Product Change Notification

Component Marking Change on Line Matching Transformer SM-LP-500x Models

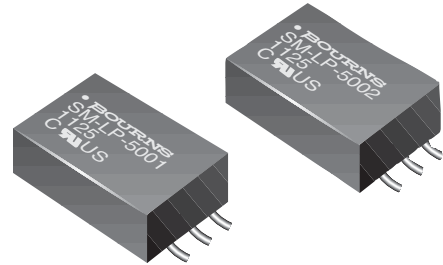
Effective with manufacturing date code 1125, Line Matching Transformer Model SM-LP-500x component nomenclature marking will be changed. The C-UL-US Component Recognition product safety agency logo will appear on new manufactured parts.
